**CITY OF CARLTON
PLANNING COMMISSION MEETING AGENDA
MONDAY, OCTOBER 19, 2020, 6:00 P.M.
VIA ZOOM**

City File# SUB 2020-01 JR Meadows Preliminary Subdivision Plan for Phase II – located at 10215 NE Old McMinnville Highway, or Assessor Map 3422 Tax Lot 1300. The applicant is requesting to subdivide existing parcel into 54 lots that are zoned R-2 (for single family homes or duplex dwellings) and one parcel would be zoned R-3 for multifamily housing. The subject property is currently zoned R-2 and R-3 as of final Council approval on September 1, 2020. The relevant subdivision standards and approval criteria in the Carlton Municipal Code are as follow:

STAFF REPORT: Preliminary Plan JR Meadows Phase 2 Subdivision
City file #SUB2020-01
Carole Connell, AICP Carlton City Planner

P-04

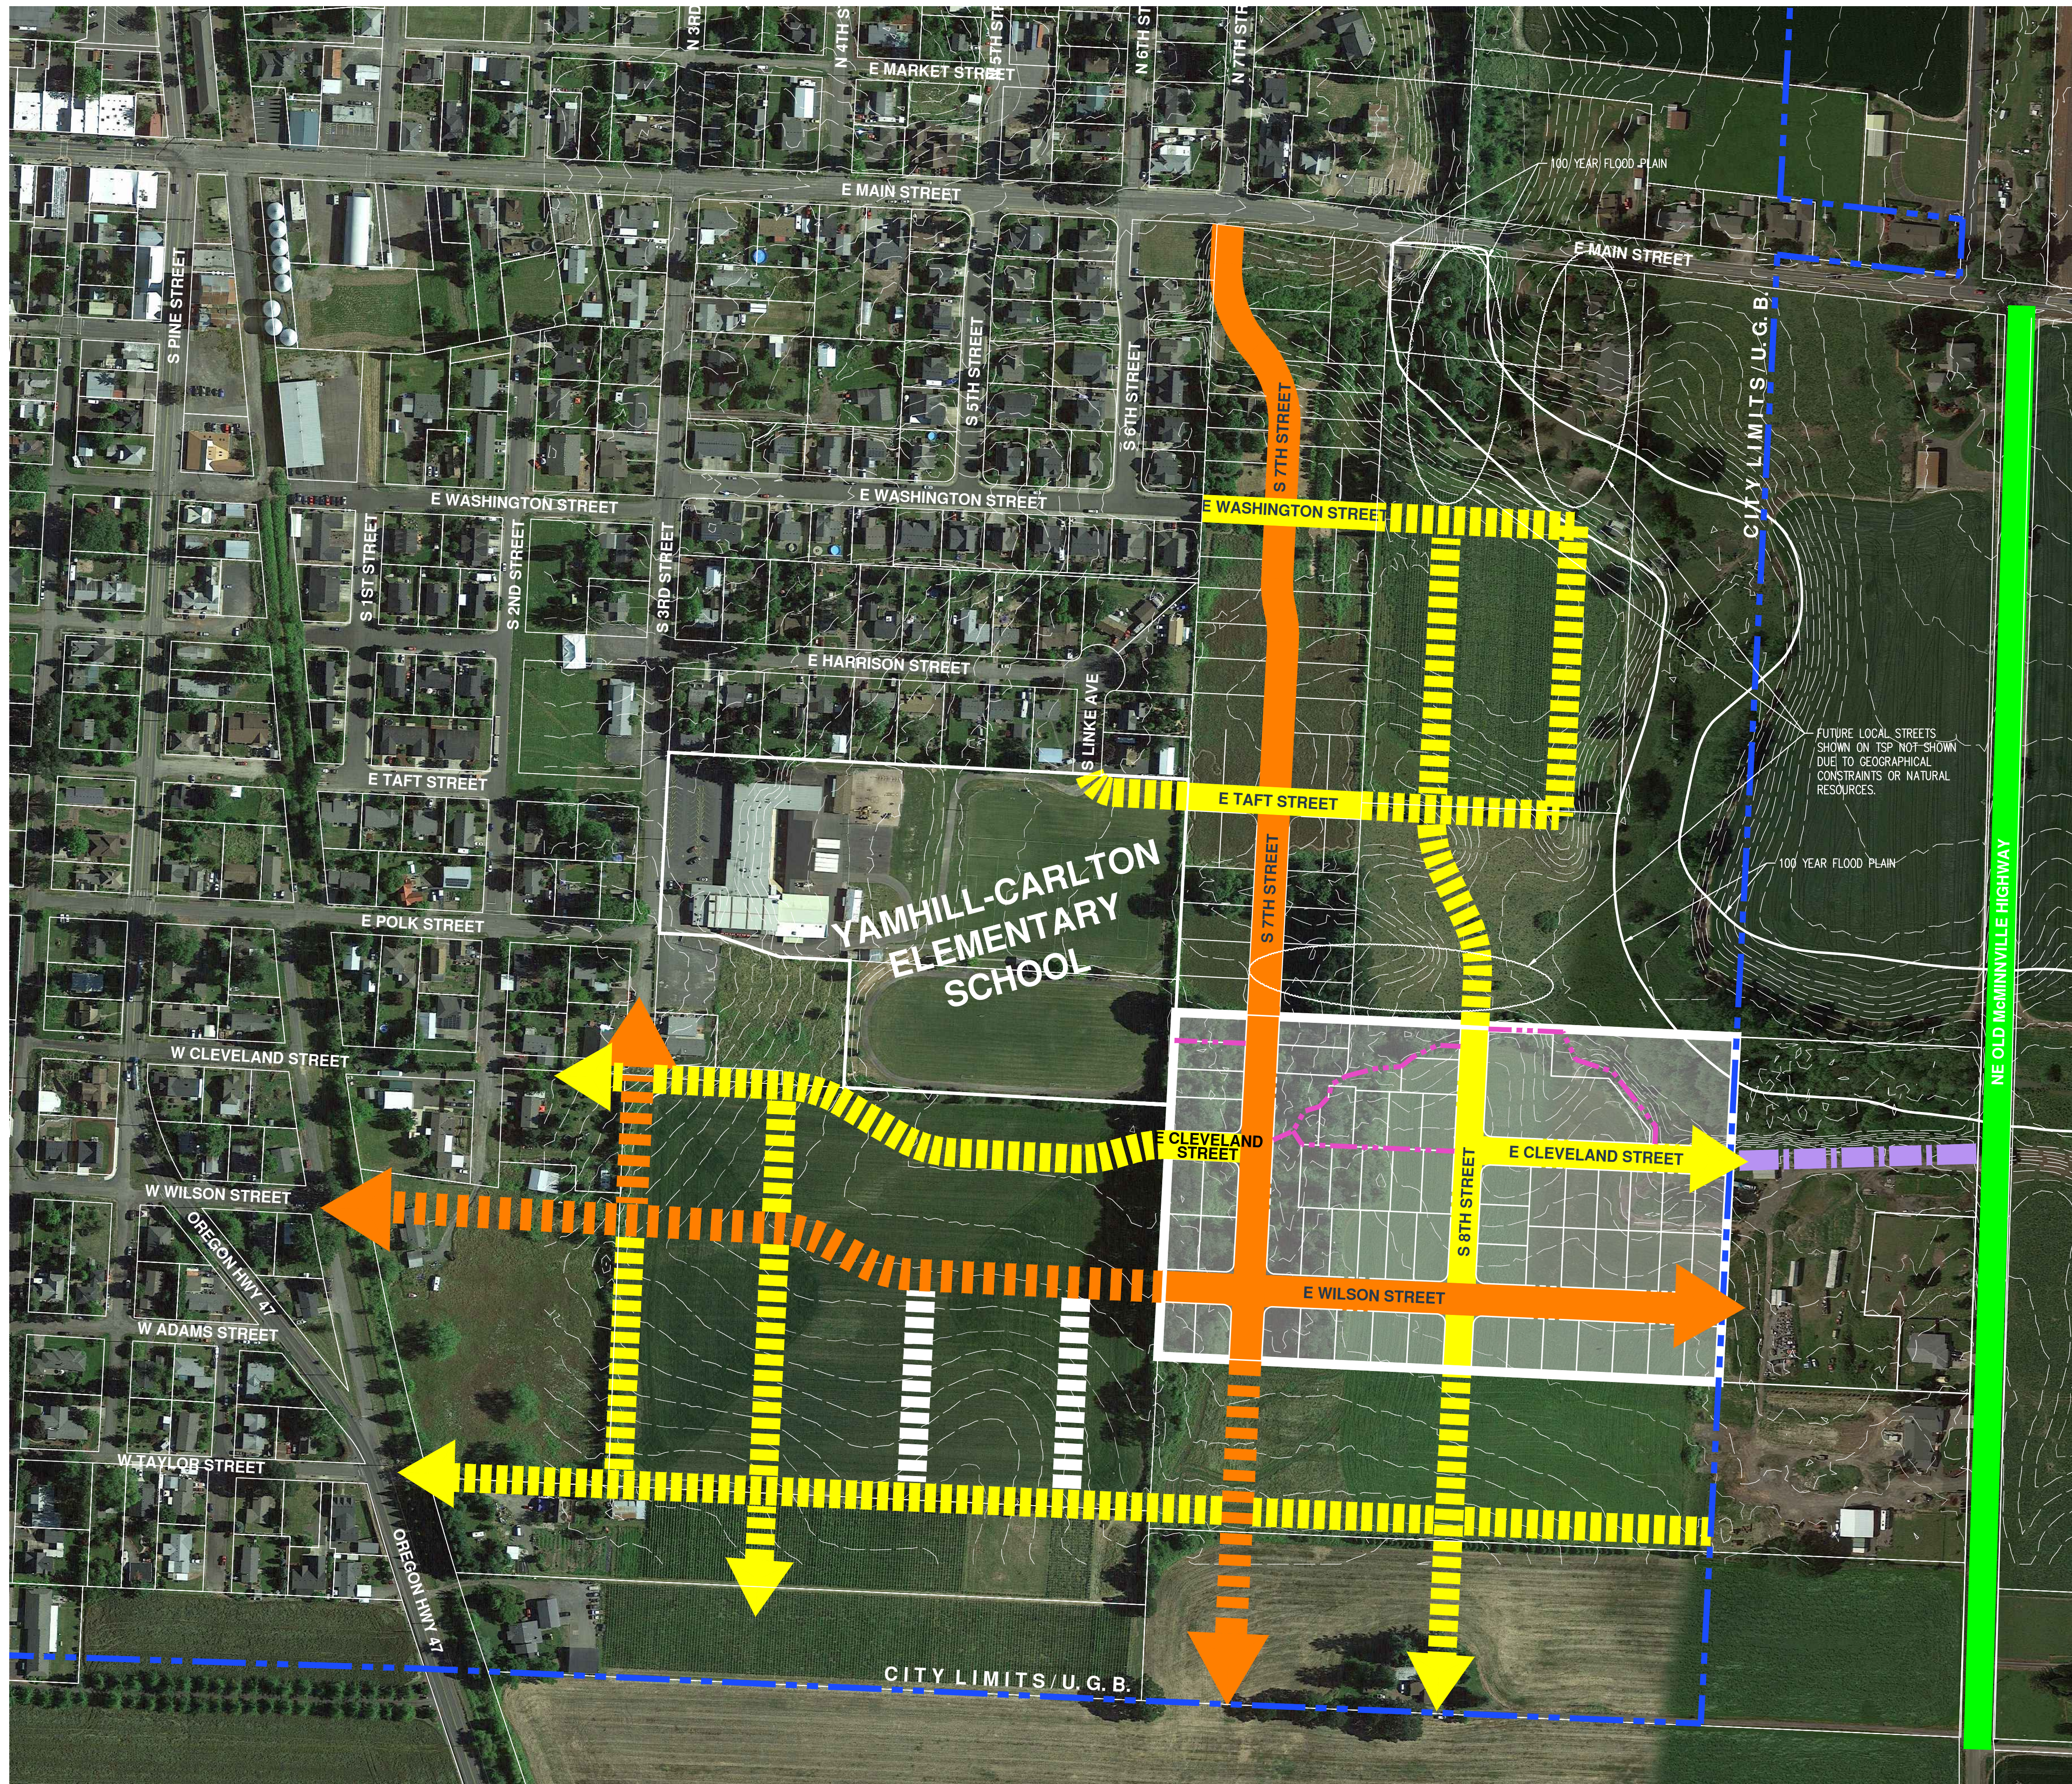
FINDINGS: The applicant's preliminary subdivision plan illustrates 54 single-family dwellings on the 11.97-acre R-2 portion, which allows potentially 120 dwelling units. The 54 single-family lots range from 6,000 to 7,450 square feet. See Sheet PO-04.

FINDINGS: The preliminary plan illustrates a single R-3 parcel, Lot #71 that is 85,964 square feet in size, noted on Sheet PO-04. The R-3 portion permits a density of 8 – 32 dwellings per acre. The applicant's concept plan estimates 22 multi-family units will be built on the buildable portion (38,015 sf) which is otherwise constrained by numerous natural features (Tract C 47,949 sf). If the subdivision plan is approved the applicant is required to apply for Major Site Development permit approval by the Planning Commission. The associated zone change approval requires 25% of the R-3 parcel to be occupied by multi-family dwellings. The plan illustrates 79% of the R-3 parcel (Lot 71) will be developed for multi-family housing

**PRELIMINARY TREE PRESERVATION AND REMOVAL PLAN
JR MEADOWS NO. 2
CARLTON, OREGON**

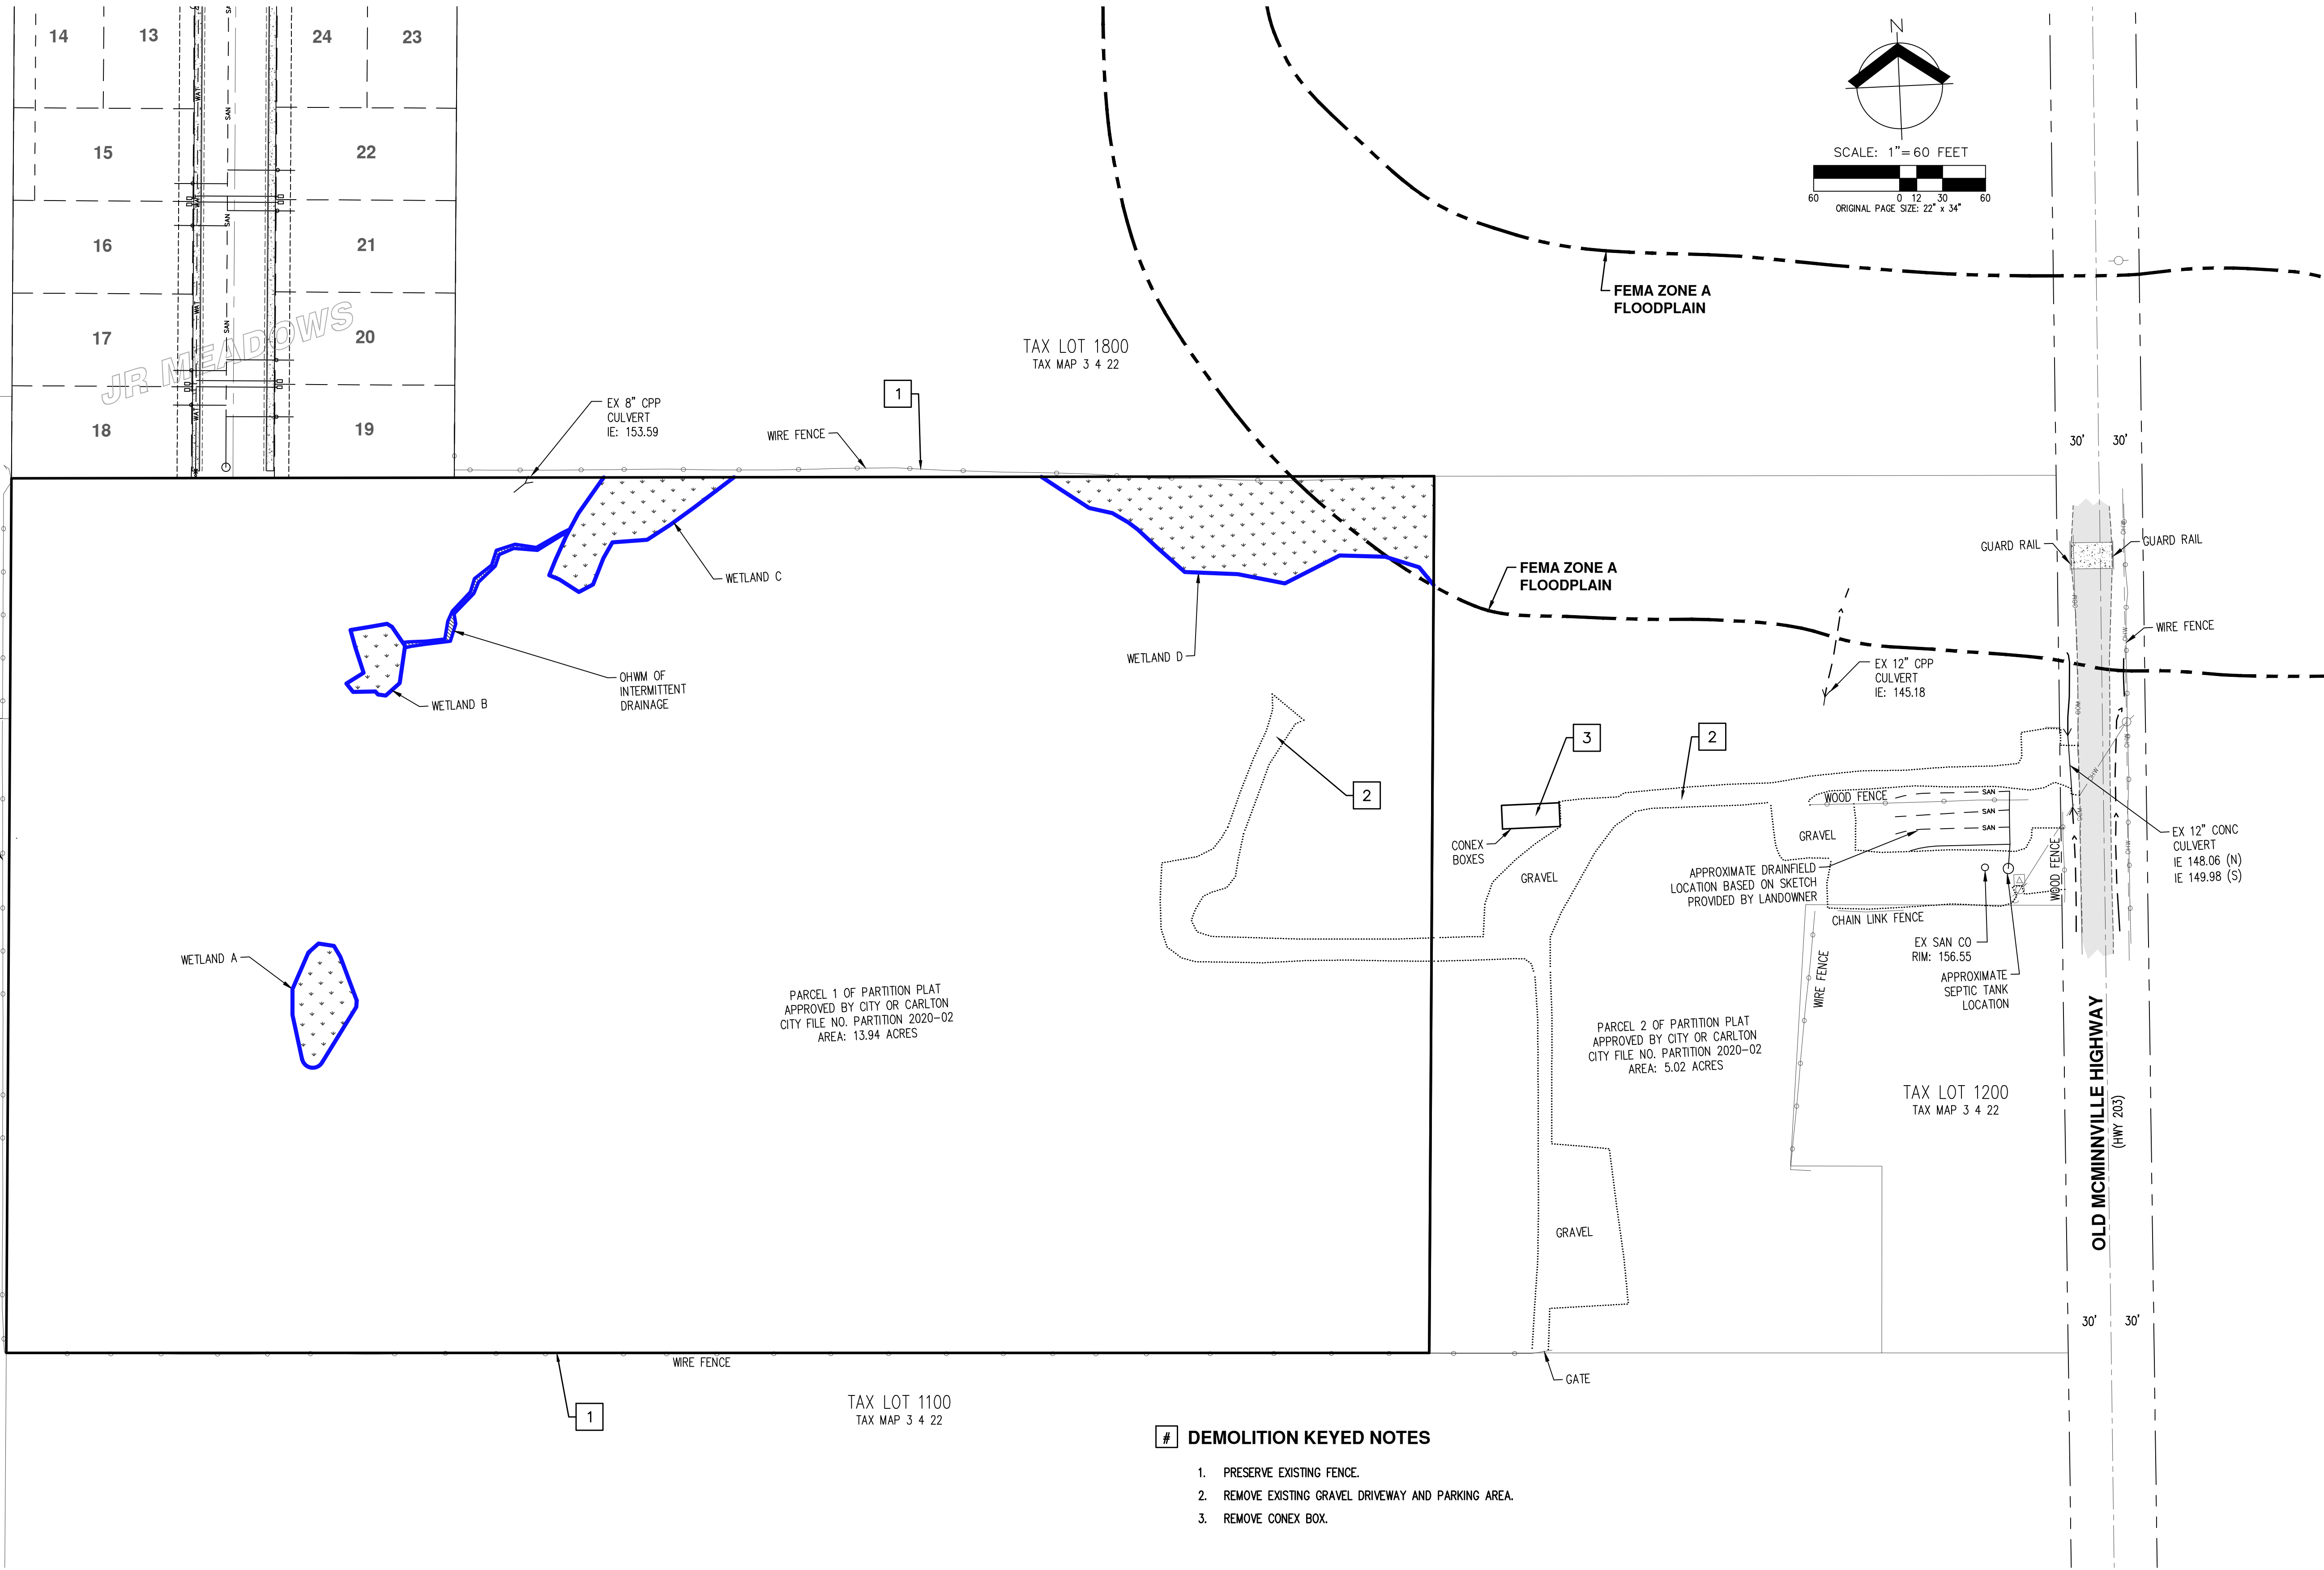
- p. The existing trees identified on sheet P-02 that are on the perimeter of the site shall be retained wherever possible. The applicant's arborist shall re-evaluate the feasibility of preserving tree # 17307, providing a written determination to city staff.
